BY JOHNSON CONTROLS

SI0268

TILTING PAD THRUST BEARING CHANGE
USED WITH 38" MULTISTAGE COMPRESSOR

THRUST BEARING CHANGE OUT

FIGURE 1 - THRUST BEARING CHANGE

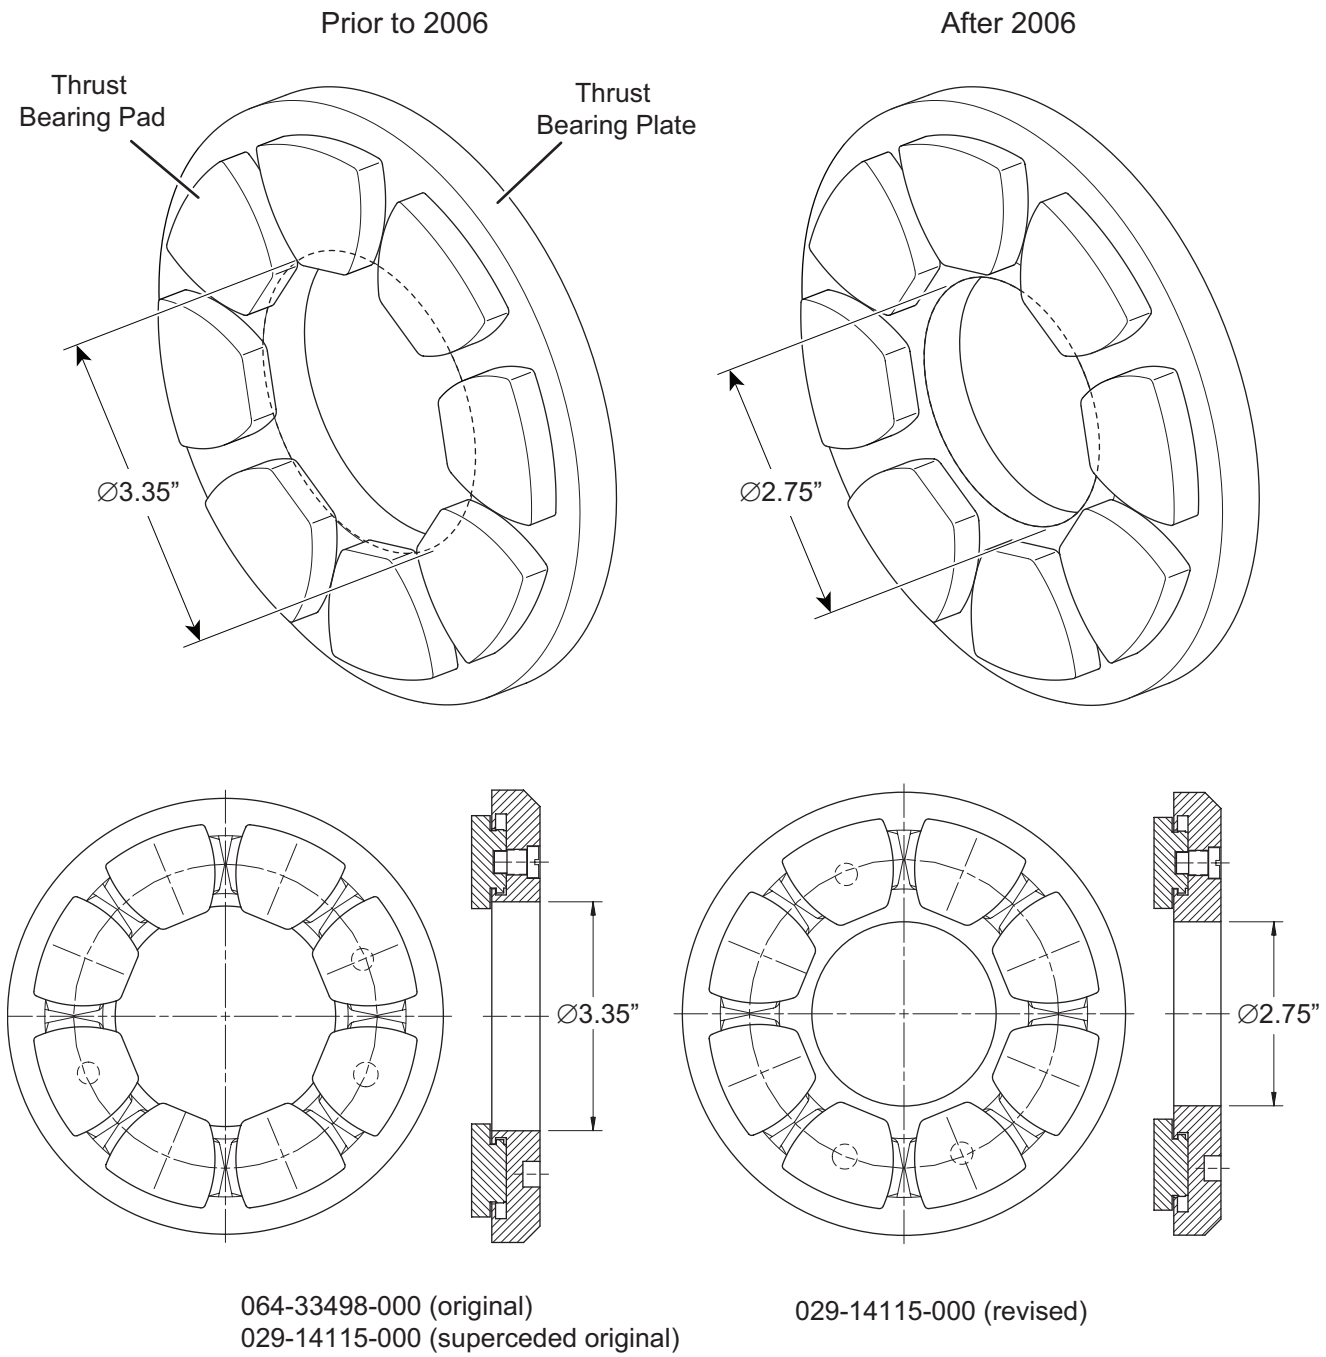
On 38" OM compressors a ventilated spacer ring is used to maintain the separation distance required to allow oil to feed between the discharge end journal bearing and the thrust bearing backing plate. Due to a dimensional change in the thrust bearing that occurred in 2006, the ventilated spacer ring can cause a blockage of the bearing oil supply. This issue only affects current production bearings (p/n 029-14115-00) that have the 2.75" dimension and not the original 3.35" bearings (p/n 064-33498-000). The figure on the following page illustrates which thrust bearings are to be addressed.

A new service kit (p/n 381-18879-000) is being developed that will contain the replacement bearing, a steel roll pin along with a drawing detailing the dimensional changes to the thrust bearing. JCI parts distribution centers will be supplying this new kit whenever the original 064-33498-000 or the superceded part number 029-14115-000 is ordered.

After receiving the kit, discard the current spacer ring used between the thrust bearing and the journal bearing. The roll pin (p/n 029-06841-000) must be inserted into the current 3/32" hole that exists on the face of the discharge end journal bearing. This new roll pin replaces the current spacer ring and will provide and maintain adequate separation distance needed between the back of the thrust bearing plate and the journal bearing to ensure proper oil flow.

After the roll pin has been inserted into the face of the journal bearing, place the thrust bearing into position in the compressor housing. The thrust bearing backing plate and the journal bearing should have visible space between them when the assembly is correct.
